North Dakota Department of Transportation

ADDENDUM 1 – JOB 23

TO: All prospective bidders on project NH-NHU-4-083(111)200, Job No. 23 scheduled for the November 18, 2016 bid opening.

Project Information		
Project: NH-NHU-4-083(111)200		PCN: 18912
Location: Minot, Ward County		
Date:10/14/16		Lead Designer: Burns & McDonnell
Bid Opening Date: 11/18/16		JOB#: 23 Addendum#: 1
Distribute to: -Grp-DOT Bids Addenda (dotbids@nd.gov)		
Section	Sheet	Description of Change
2	1	<ul style="list-style-type: none"> Deleted Section 85 Landscaping Added Section 130 Guardrail Updated Section 6 (page 1-5 Notes and page 6 Environmental Notes) Added SP 0386(14) Removed SP 0363(14)
2	2	<ul style="list-style-type: none"> Added Guardrail Standard Drawings D764-1,5,22
4	1	<ul style="list-style-type: none"> Updated extents of imprinted concrete Removed sidewalk South of the bridge, West of US-83 Updated edge of pavement due to guardrail addition
6	ALL	<ul style="list-style-type: none"> Updated plan note on 100-P01 to include coordinating use of Temporary Construction Easement between projects Added additional details/updates to 105-P02 Adding 105-P02 shifted all other notes and all sheets had to be repr

Revised 10/7/2016	STATE	PROJECT NO.	SECTION NO.	SHEET NO.
	ND	NH-NHU-4-083(111)200	77	1

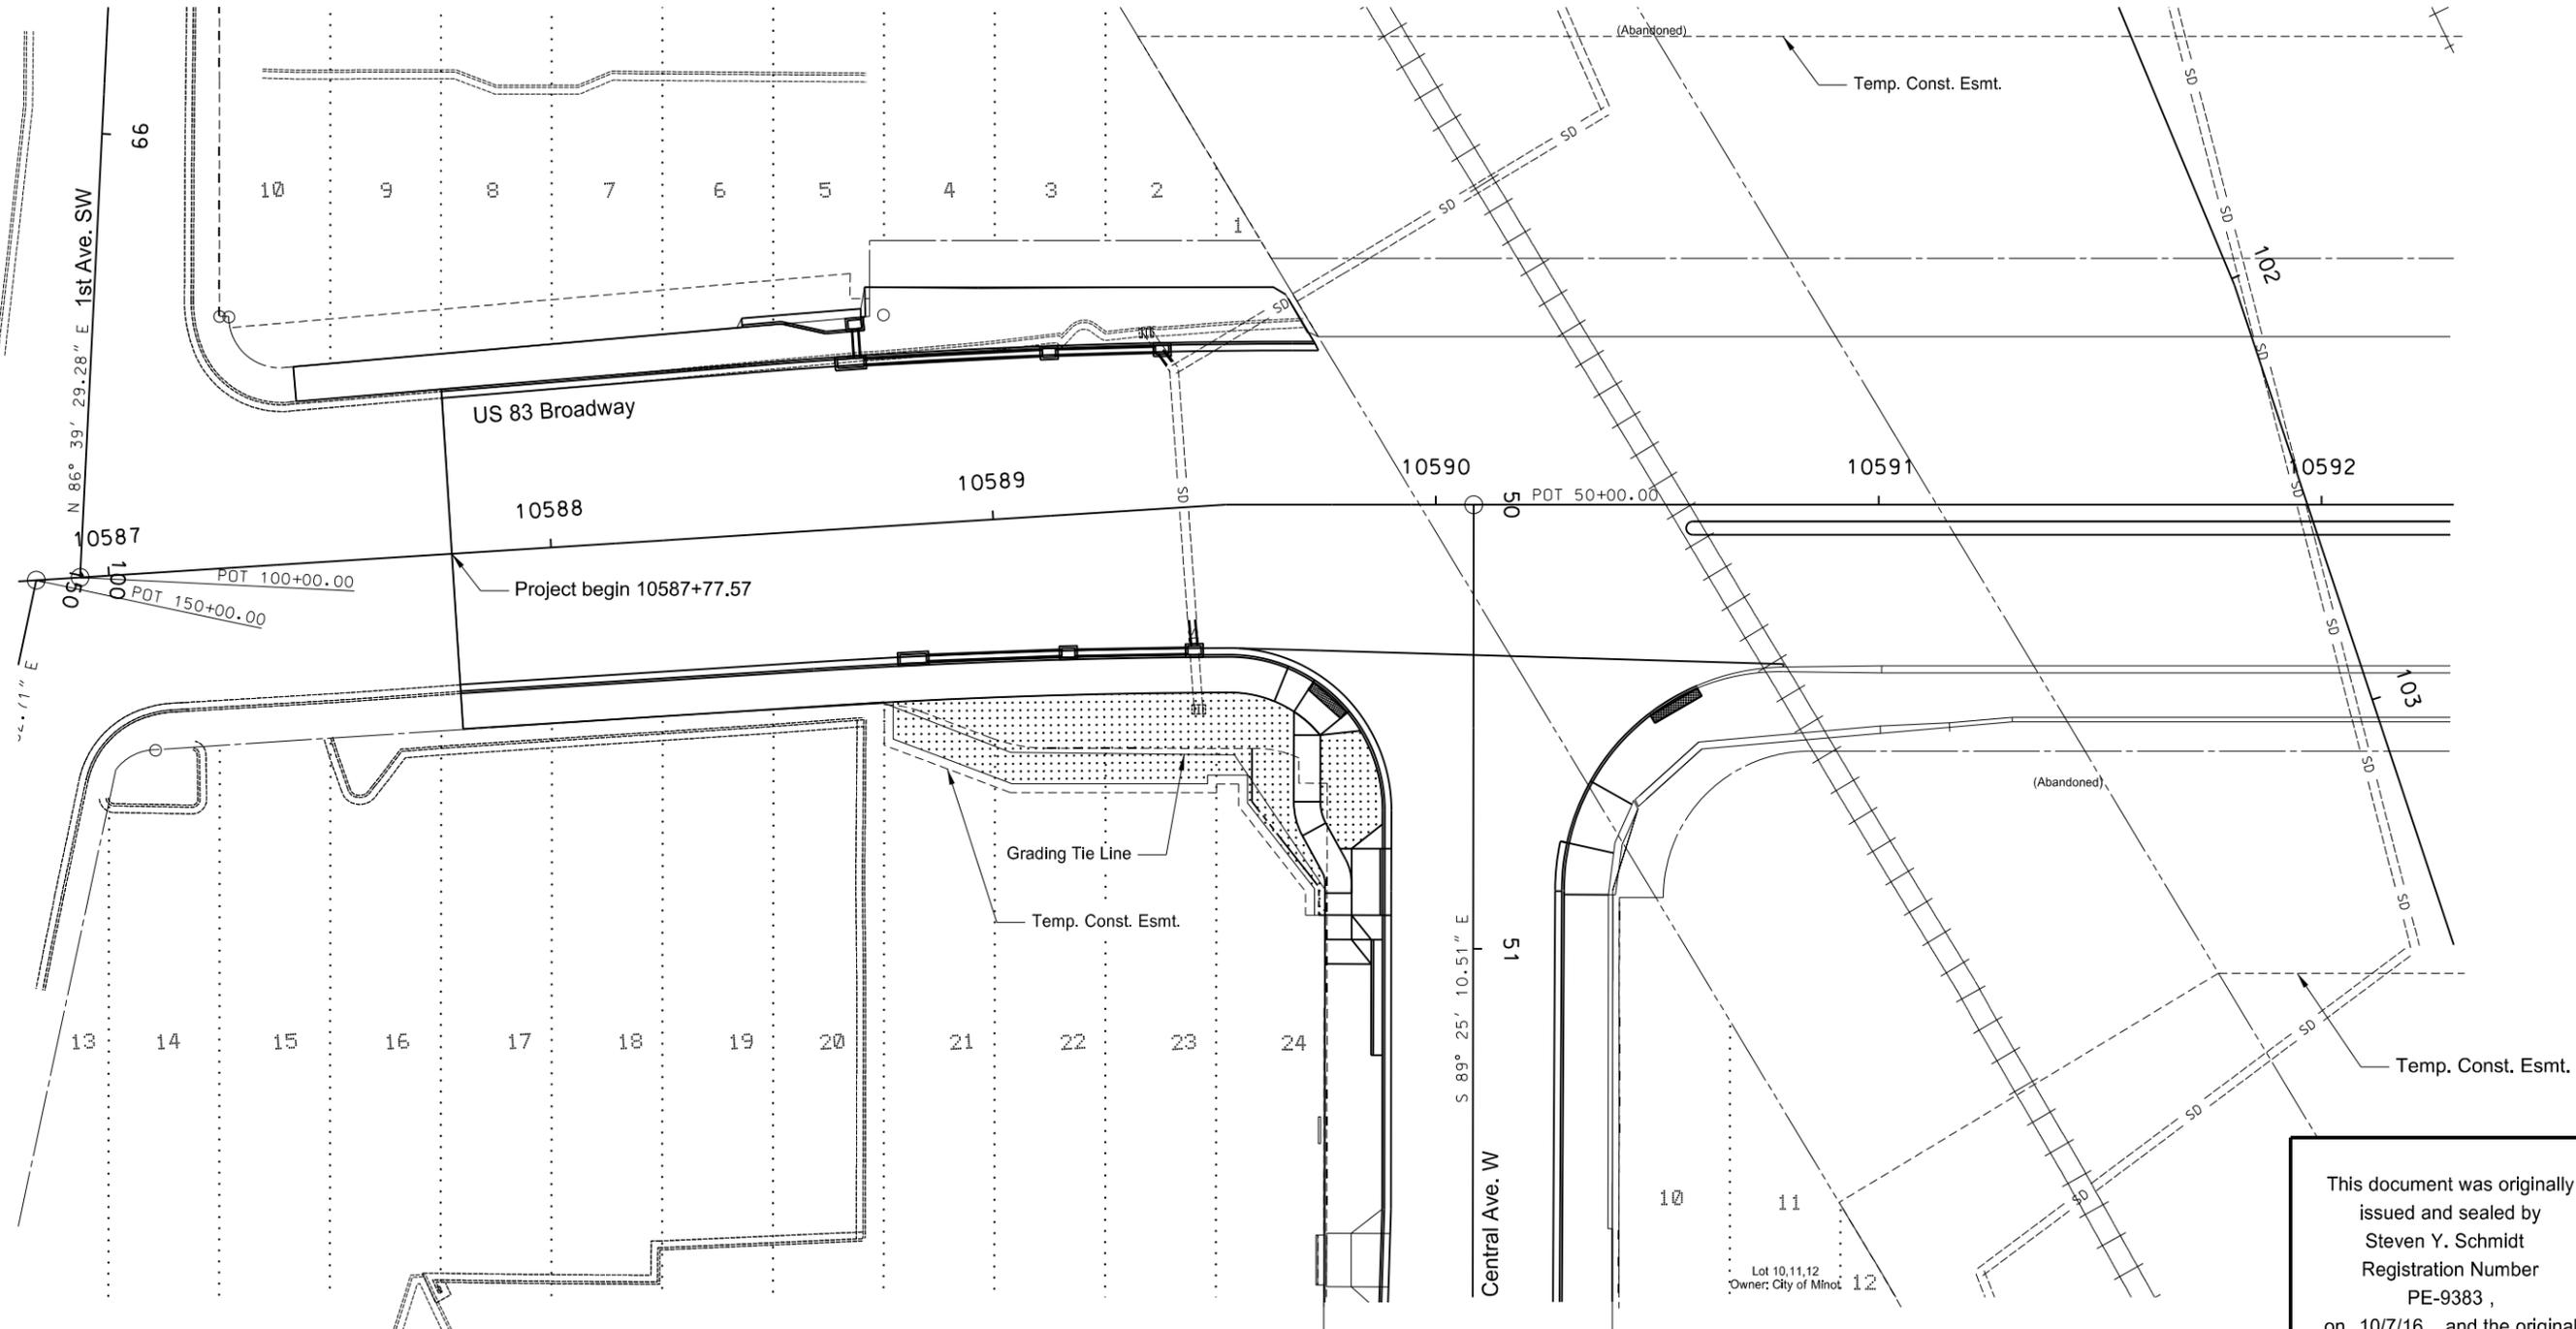
76	5	<ul style="list-style-type: none"> No design change, just reprinted to show updated drainage and imprinted concrete
77	1	<ul style="list-style-type: none"> No design change, just reprinted to show updated drainage and imprinted concrete
77	2	<ul style="list-style-type: none"> Added additional grading details to abutment 8 Added guardrail to drawing Updated seeding and mulch quantities by 0.1 acres

Revised 10/14/2016	STATE	PROJECT NUMBER	SECTION NO.	SHEET NO.
	ND	NH-NHU-4-083(111)200	170	2

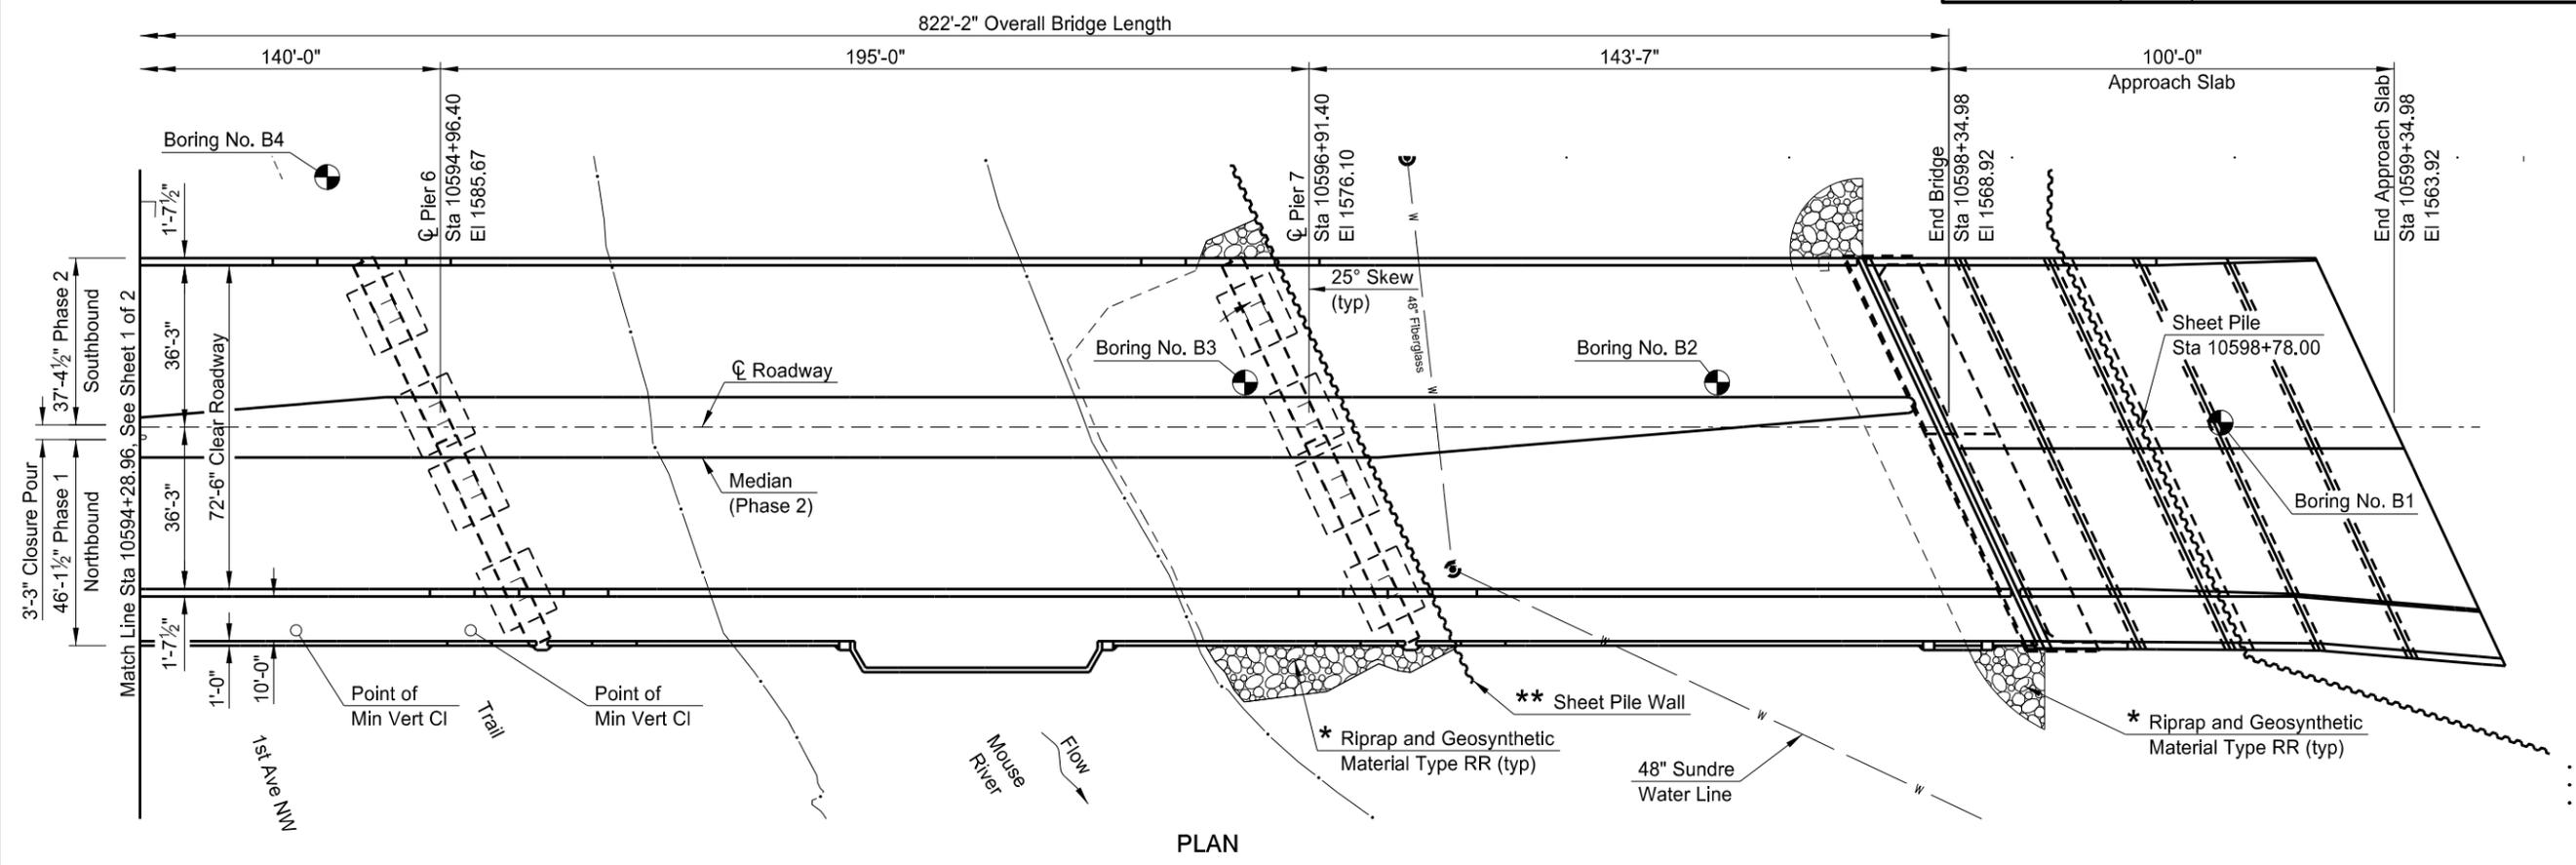
170	2	<ul style="list-style-type: none"> • Added bottom of footing elevations • Changed water elevation shown from “Ordinary High Water” to “50 Year” • Added sheet pile wall to Elevation view • Added “Median” callout • Clarified that ground line shown (Existing and Proposed) is along the CL roadway • Turned off Stationing, lights, contour lines, Right of Way lines, utilities that aren’t adjacent to bridge, sidewalks and curbs not on bridge
170	3	<ul style="list-style-type: none"> • Added permissible timing for removal
170	4	<ul style="list-style-type: none"> • Revised 602 notes
170	6	<ul style="list-style-type: none"> • Added OSHA note; changed BNSF contact; removed POX from geosynthetic reinforcement
170	7	<ul style="list-style-type: none"> • Increased table text size • Corrected “Item Description” for “Pile Supported Approach Slab”, “Bridge Approach Slab Remove & Replace”, “Finger Expansion Joint” • Corrected “Structural Engineer” unit to “MHR” • Updated Quantity for Class 1 Excavation, Class AE-3 Concrete, Re-Steel Grade 60, and HP14x73 Piling (due to pile layout change at Piers 2-4) • Updated Quantity for Re-Steel Grade 60 Epoxy (due to lengthening of bars in Abut 8)

Revised 10/14/2016	STATE	PROJECT NUMBER	SECTION NO.	SHEET NO.
	ND	NH-NHU-4-083(111)200	170	18

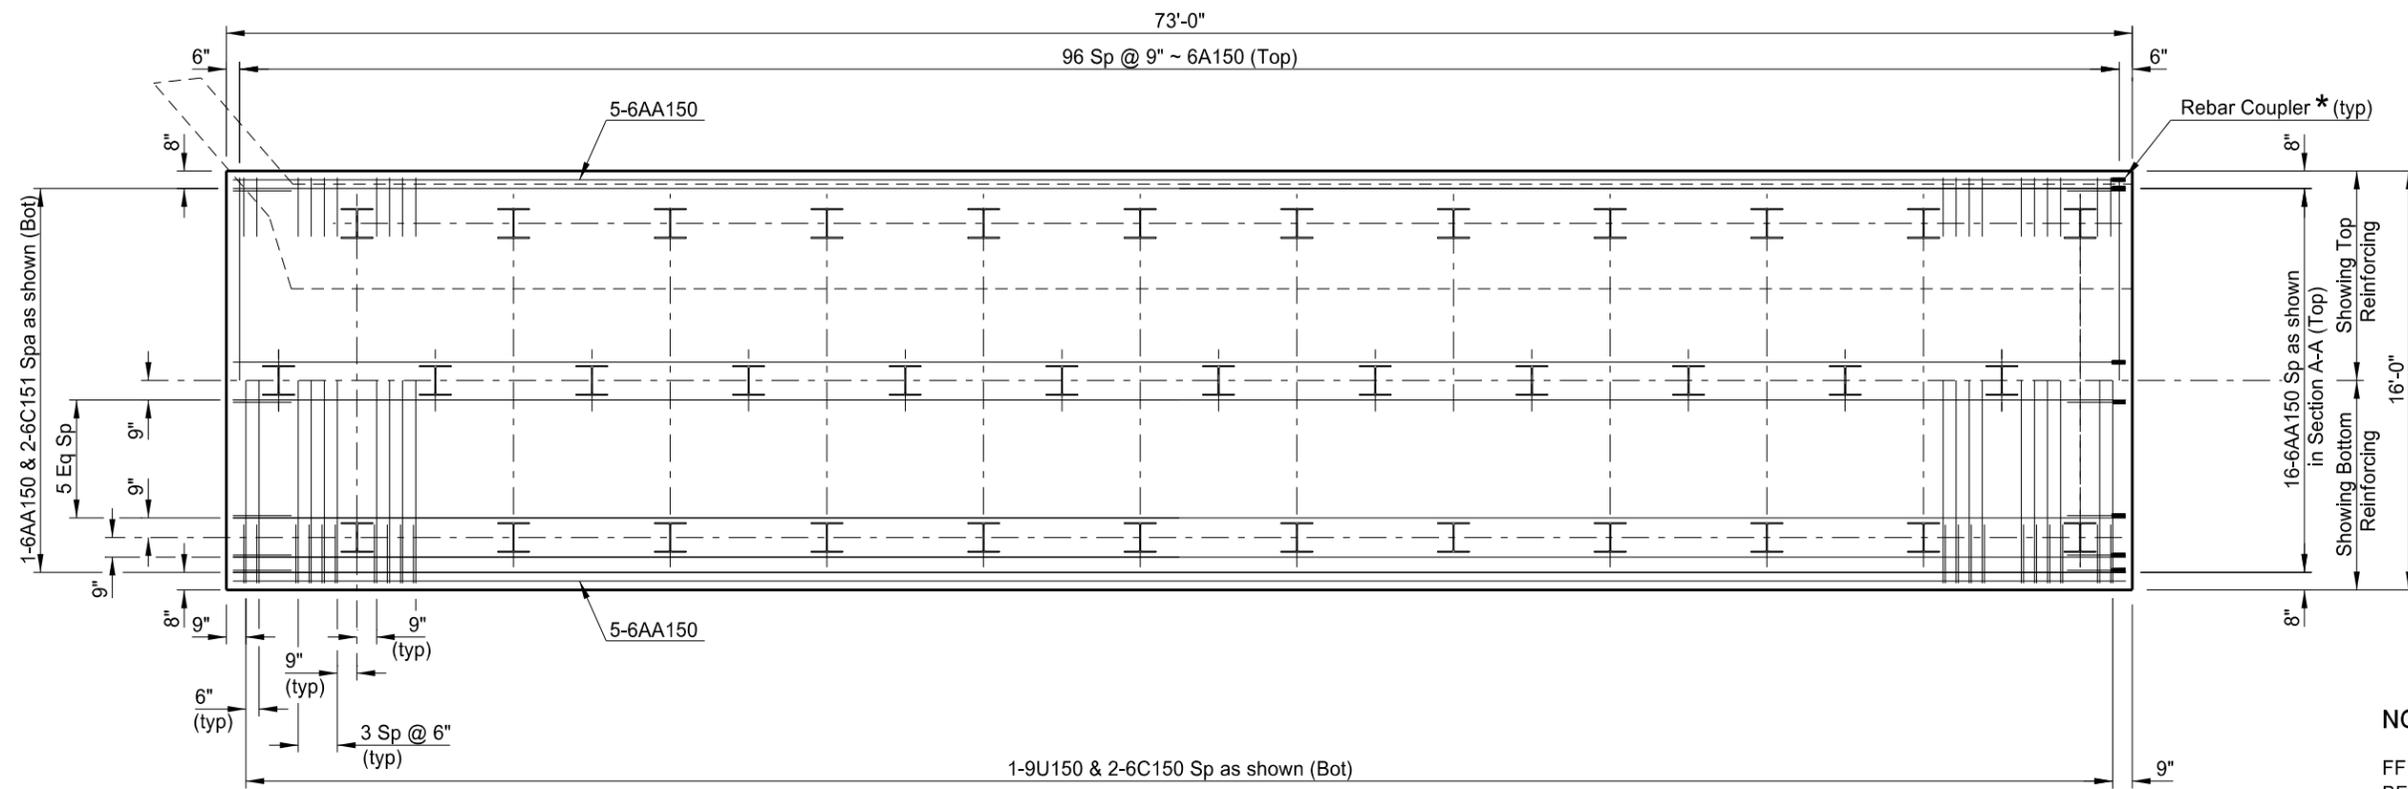
170	8	<ul style="list-style-type: none"> • Added centerline proposed roadway
170	9	<ul style="list-style-type: none"> • Added centerline proposed roadway
170	11	<ul style="list-style-type: none"> • Modified Pile Layout at Piers 2 & 3 to have 9 piles at each footing • Modified associated pile coordinates
170	12	<ul style="list-style-type: none"> • Modified Pile Layout at Pier 4 have 9 piles at each footing • Modified associated pile coordinates
170	13	<ul style="list-style-type: none"> • Changed skew at girder seat locations
170	14	<ul style="list-style-type: none"> • Has been updated to match latest NDDOT details on PPG
170	15	<ul style="list-style-type: none"> • Updated pipe & aggregate callout to match PPG
170	16	<ul style="list-style-type: none"> • Fixed conduit sketch and sheet reference
170	17	<ul style="list-style-type: none"> • Updated underdrain details to match PPG
170	18	<ul style="list-style-type: none"> • Added rebar couplers for Phase 2

Revised	10/14/2016	STATE	PROJECT NUMBER	SECTION NO.	SHEET NO.
		ND	NH-NHU-4-083(111)200	170	21

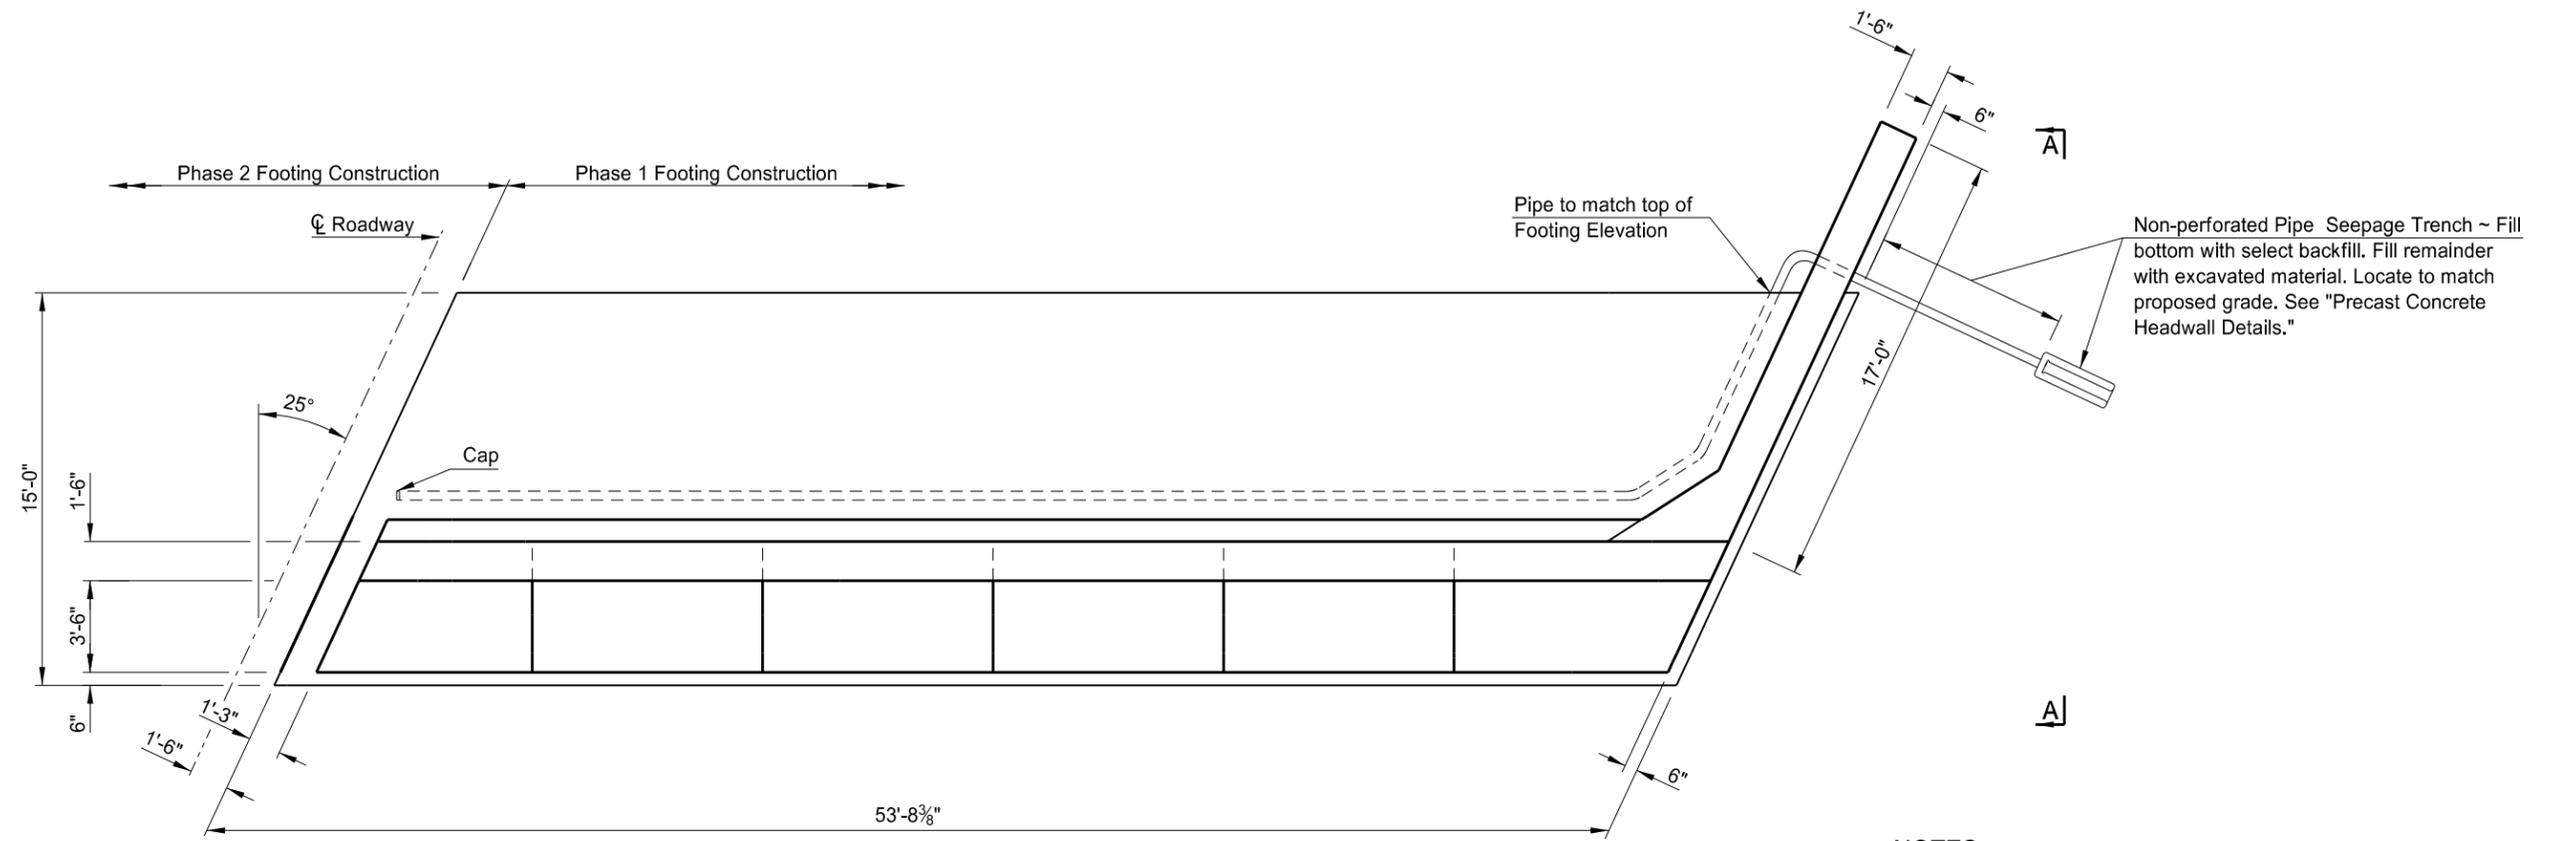
<ul style="list-style-type: none"> • Added construction joint callout
170	21	<ul style="list-style-type: none"> • Modified pipe callout
170	22	<ul style="list-style-type: none"> • Changed skew at girder seat locations
170	23	<ul style="list-style-type: none"> • Added 5XB102, 5XC103, and 5XC102 bars and callouts; added section B-B
170	24	<ul style="list-style-type: none"> • Adjusted 5XT102 bar and callout • Modified epoxy coated rebar weight • Removed 2 bars • Added rebar couplers for Phase 2
170	25	<ul style="list-style-type: none"> • Added 5XT102 Bars in section; Added heights to abutment that were originally "varies"; clarified callouts in section A-A • Added fillet information • Adjusted elev and dimension for joint filler on top of wall
170	26	<ul style="list-style-type: none"> • Updated to accommodate reduction in # of piles per footing from 12 to 9 • Added groundline and top of rail • Clarified anchor well callout
